AIR - HP COMPRESSOR VARIABLE STATOR VANE ACTUATOR (VSVA) LINEAR VARIABLE DIFFERENTIAL TRANSFORMER (LVDT) SEALING - 3 - MOD.ENG-75-0028

V2500-ENG-75-0028

Location of joint faces on VSVA to be sealed
Fig.1

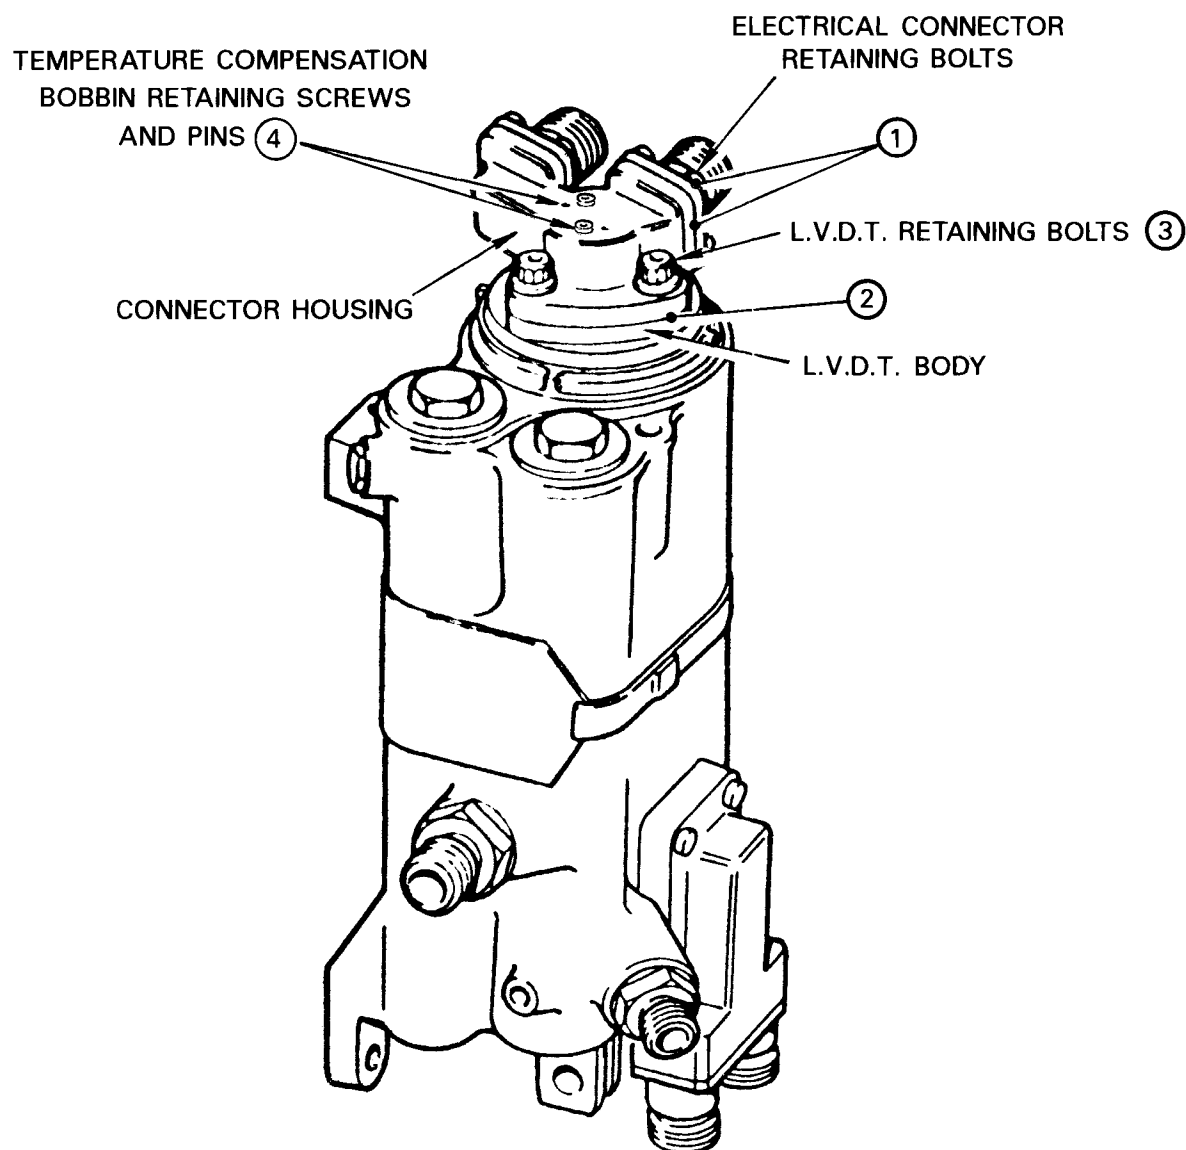
- (a) The connectors and the connector housing and the retaining bolts. Refer to Figure 1, Index 1.
 - (b) The connector housing and the LVDT body. Refer to Figures 1 and 2, Index 2.
 - (c) The LVDT retaining bolts and washers (3 off). Refer to Figures 1 and 3, Index 3.
 - (d) Bobbin retaining screws (2 off) and location pins (2 off). Refer to Figure 3, Index 4.
- (4) Ensure that each area is free from grease and dirt.
 - (5) Seal the VSVA LVDT

- (a) When the cleaning agent has evaporated apply Ardrex 3302 to the outside joint areas cleaned above, using a 5 mm soft brush.

- (a) Ensure that a reddish brown coating of the Ardrex 3302 completely covers the specified areas.
- (6) Close the left thrust reverser half by the approved procedures in Reference (1), Chapter/Section 78-32-00, Maintenance Practices.
 - (7) Close the fan cowls by the approved procedures in Reference (1), Chapter/Section 71-13-00, Maintenance Practices.
